STATE OF MAINE
DEPARTMENT OF TRANSPORTATION
16 STATE HOUSE STATION
AUGUSTA, MAINE 04333-0016

May 6, 2019
Subject: Bridge Rehabilitation
State WIN: 022812.00
Location: **Ashland**
Amendment No. 3

USGS 01015800 Aroostook River near Masardis, Maine

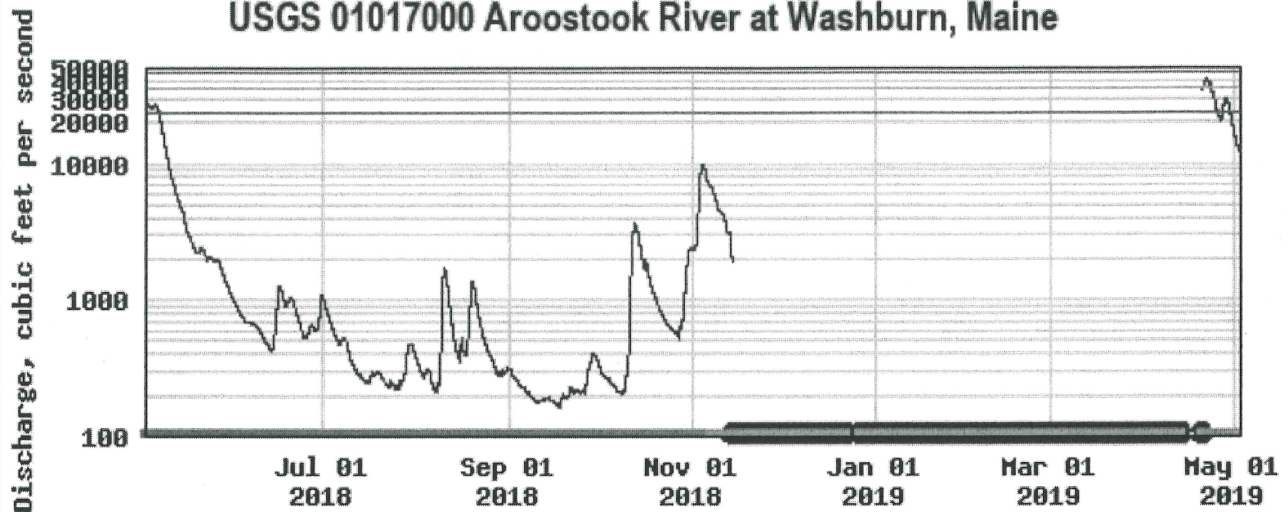
Question: In order to adequately design a temporary access trestle, the Department should provide ordinary high water, and other pertinent hydraulic data for the Aroostook river during spring run off at the bridge site.

Response: The Department has not completed a hydraulic analysis for this project, however, there is USGS stream gage information available for the Aroostook River near Masardis (upstream) and Washburn (downstream). See below gage height graphs for the past 12-month period at each respective gage, as obtained on the following website: <https://waterdata.usgs.gov/nwis>.
